CROSSED COUNTERSUNK SCREW ISO7046 / DIN965

GCSHSC-7046

E5037

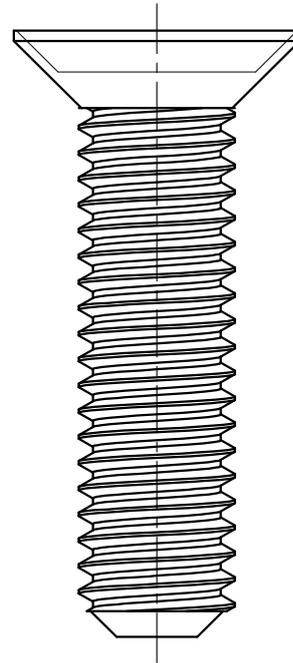
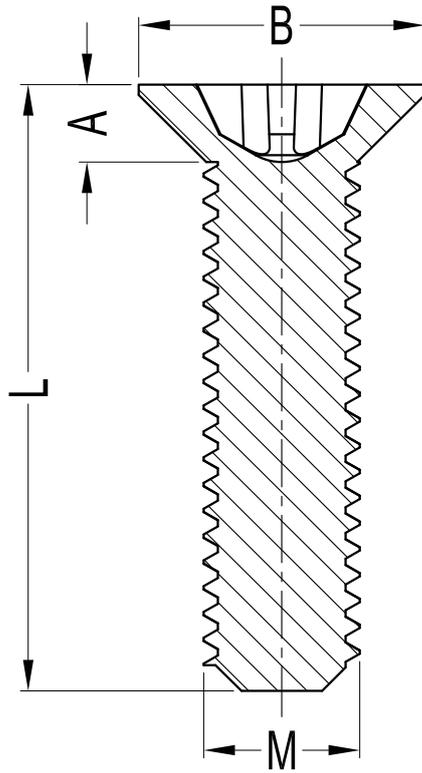
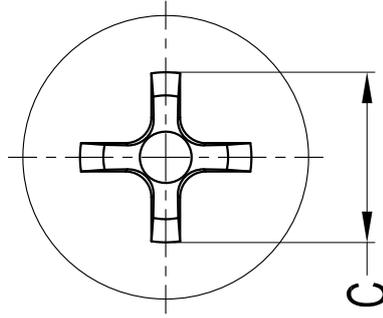
REV	DESCRIPTION	DATE	CHECK
A1	The mark position of "L" changed	2016-4-13	FDL
A2	①1.35 Change to 1.65; ②2.0 Change to 2.7; ③2.5 Change to 2.7; ④3.0 Change to 3.3; ⑤Ø7.6 Change to Ø8.4; SEE TABLE	2016-7-14	FDL
